Amendments to the Drawings

Annotated Marked-Up Drawings

REMARKS**Statement of Substance of Interview**

FIG. 6

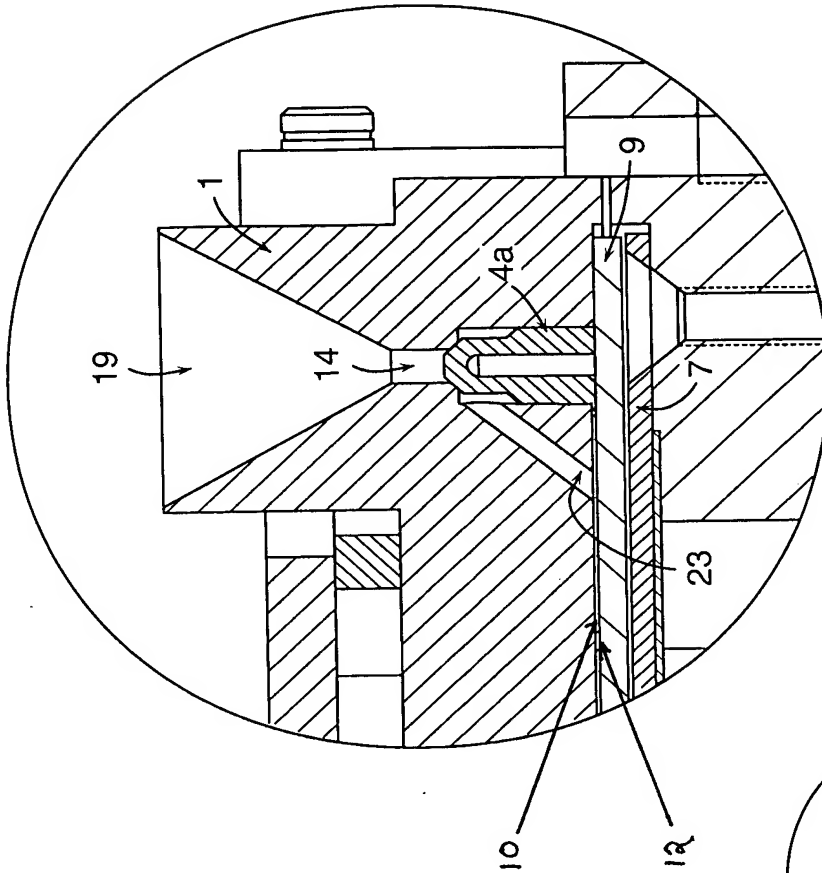
In Figure 6, reference numerals 10 and 12 have been added from Figure 7.

FIG. 10

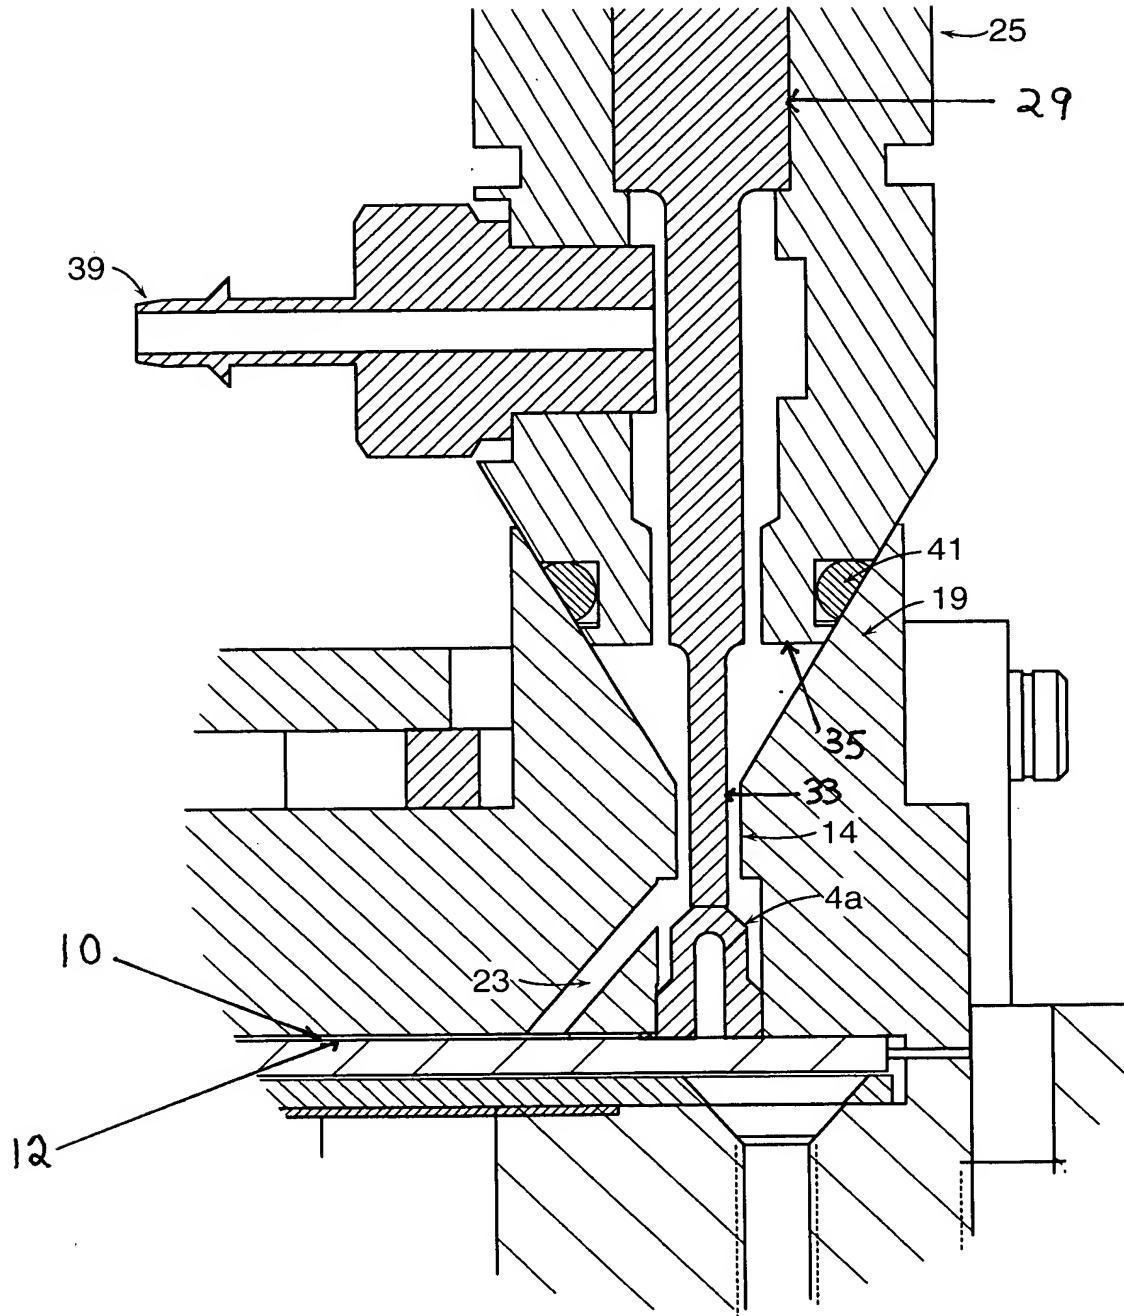
In Figure 10, reference numerals 29, 33 and 35 have been added from Figure 9 and reference numerals 10 and 12 have been added from Figure 7.
